WATTS BAR NUCLEAR PLANT (WBN) UNIT 1 - AMERICAN SOCIETY OF MECHANICAL ENGINEERS (ASME) INSERVICE INSPECTION (ISI) PROGRAM REQUEST FOR RELIEF 1-ISI-16, 1-ISI-17, 1-ISI-18, AND 1-ISI-19 - REQUEST FOR ADDITIONAL INFORMATION (TAC NOS. MC 9638, MC9639, MC9640, MC9641)

The purpose of this letter is to provide a response to NRC's request for additional information dated April 27, 2006, concerning TVA's request for relief dated January 25, 2006.

WATTS BAR NUCLEAR PLANT (WBN) UNIT 1
REQUEST FOR RELIEF
1-ISI-16, 1-ISI-17, 1-ISI-18, AND 1-ISI-19

WATTS BAR NUCLEAR PLANT (WBN) UNIT 1
REQUEST FOR RELIEF
1-ISI-16, 1-ISI-17, 1-ISI-18, AND 1-ISI-19
VENDOR'S NOZZLE SKETCH

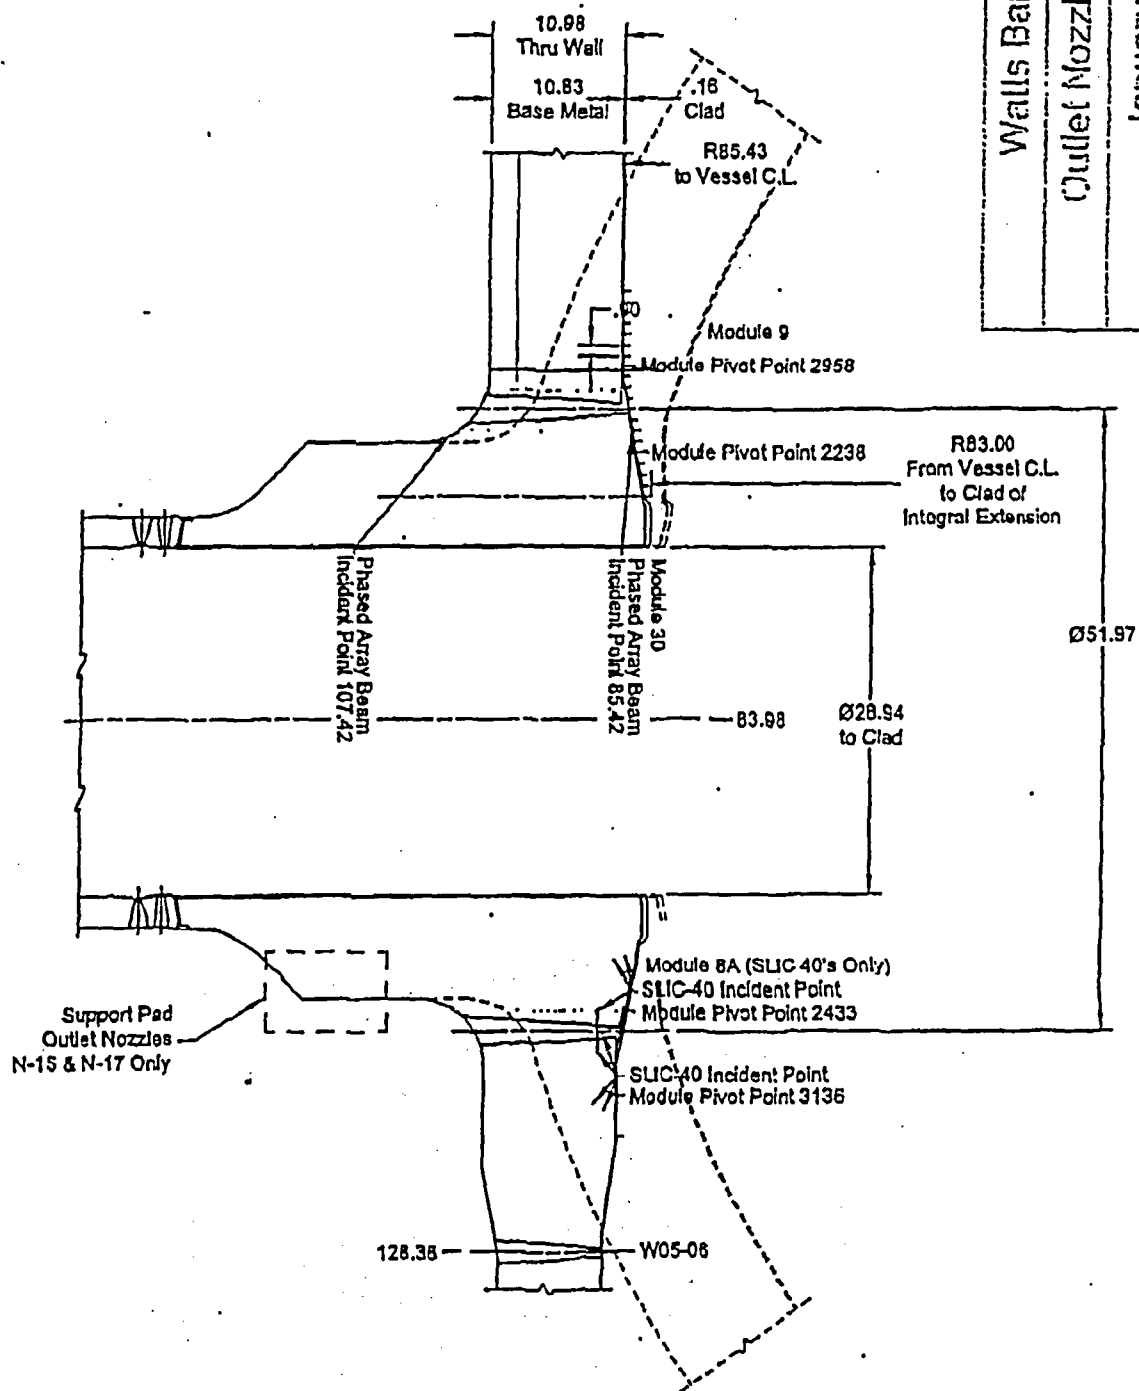
Provide details showing ultrasonic beam angles used to find the two code allowable indications in weld-18 and the coverage obtained in the area of the flaws. Also, provide details showing the ultrasonic beam angles for any additional interrogation of these two code allowable indications in weld-18 and any additional coverage obtained in the area of the flaws.

Describe the outlet nozzle integral extension and how it restricts the ultrasonic search unit scan surface, thereby limiting the two-direction transverse coverage.

A nozzle sketch from the vendor examination report, which shows the beam angles utilized for the outlet nozzle to vessel scan is included in Attachment 3. This sketch identifies the transducer and scan direction performed during the inspection.

The sketch referenced in Question 7, (Attachment 3), shows a basic outline of the integral extension of the outlet nozzle. As seen in the sketch, the outlet nozzle extension extends outward from the inside surface of the nozzle. The height and radius of this design prevents the transducers from mating to the surface, thereby, preventing sound from passing from the transducer to the inside surface of the reactor vessel.

Note: Check for limitations due to the proximity of shell wall taper and integral extension.
